### APPEAL SUMMARY

| <b>Appeal ID:</b> 22278  | <b>Project Address:</b> 1945 SE Harrison St  |
| <b>Appeal Involves:</b> Alteration of an existing structure, occ Change from Basement to ADU | <b>LUR or Permit Application No.:</b>  |

| <b>Code Section</b> | M1503 Range Hoods  |

# a2.00 BASEMENT LEVEL FLOOR PLAN

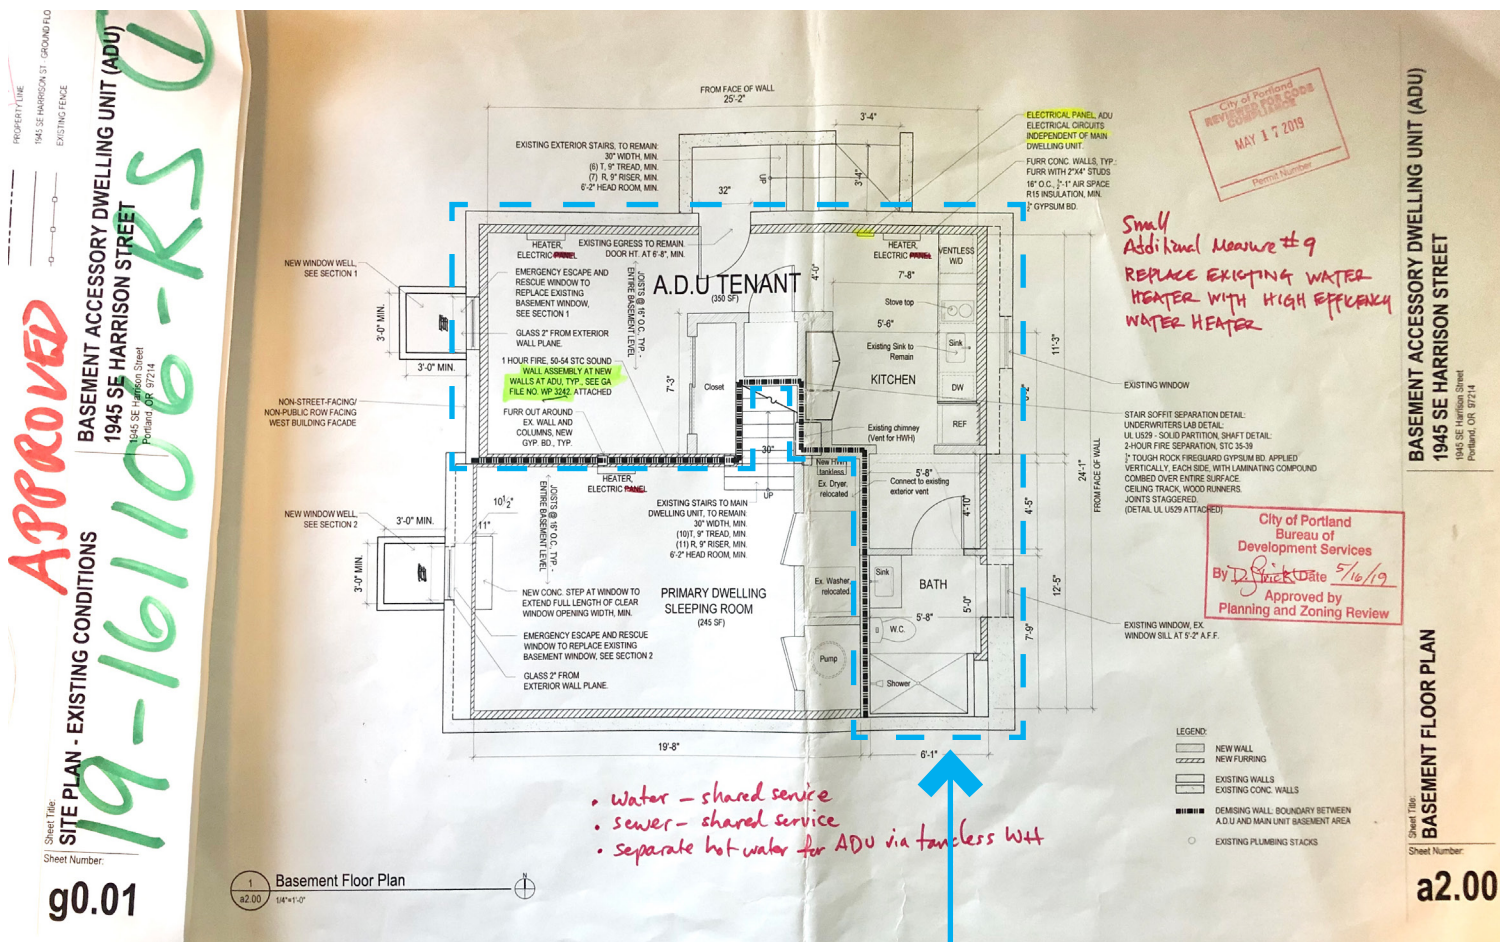
Omission of ducted range hood in Accessory Dwelling Unit conversion, and request for approval of proposed alternate of: Provision of small, electric (non-gas) induction cooktop surface in combination with adjacent window, design for increased cross-ventilation, and proximate bathroom ventilation.

The ADU is very small and the kitchen was located to take advantage of an existing sink, and so could not have reasonably been located elsewhere. There is an operable window directly in front of the cooktop. Additionally, the front door is approximately ten feet away, there is an egress window on the opposite western wall, and another operable window is located in the bathroom. Together these windows provide ample cross ventilation. The Kitchen-adjacent bathroom has been constructed with a 110-CFM exhaust fan, exhausting directly to the outdoors.

(1a) The electric cooktop has been located directly below the existing operable window in the Kitchen, within 2' of the clear window opening.

(1b) The electric cooktop is within 10' of the bathroom, which is exhausted directly to the outdoors, and has an additional operable window.

**Omission of ducted range hood in ADU: Denied. Proposal does not provide equivalent Life Safety protection.**

# PHOTOS OF CONSTRUCTED COOKTOP

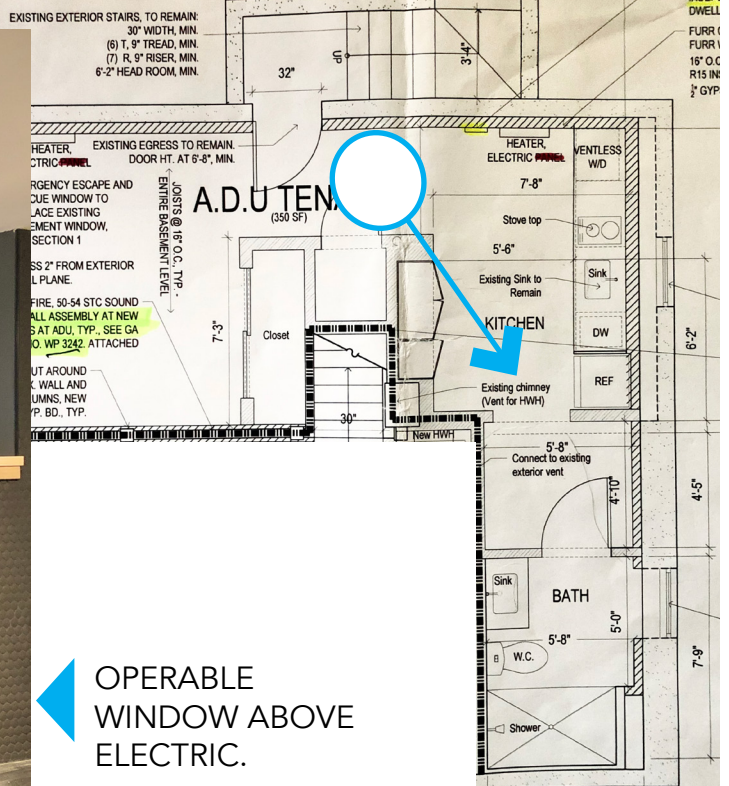
BATHROOM WITH OPERABLE WINDOW AND EXHAUST FAN, EXHAUSTING DIRECTLY TO THE EXTERIOR

ALL JOISTS RUNNING IN  
NORT-SOUTH DIRECTION  
THROUGHOUT BASEMENT,  
INCLUDING AT COOKTOP

NON-CONTINUOUS  
WALL ABOVE  
COOKTOP AT  
CONCRETE WALL.

MIN. CEILING HT  
ABOVE COOKTOP.

VIEW FROM KITCHEN  
WEST TOWARD NEW  
LARGE OPERABLE EGRESS  
WINDOW.

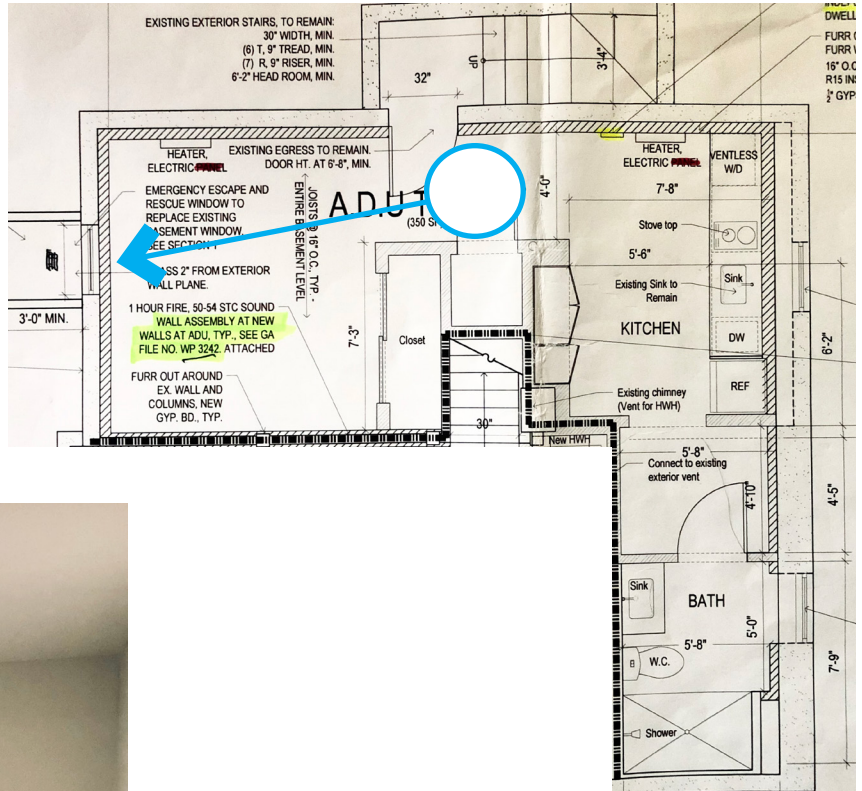
(2b) The new 9-SF (based on 9 sf egress, updated) operable window in the sleeping area was not required to meet safe egress requirements, but rather was designed by owner to increase light and ventilation within the ADU. This newly constructed window is located on the West wall, opposite all of the existing windows, and thus is critical to providing improved and safe through- and cross-ventilation within the ADU. A total of 44sf (based on 9 sf egress, updated) of operable window opening in a 350-SF Accessory Dwelling Unit is thought to provide sufficient ventilation to operate plug-in electric, standard-watt, appliances.
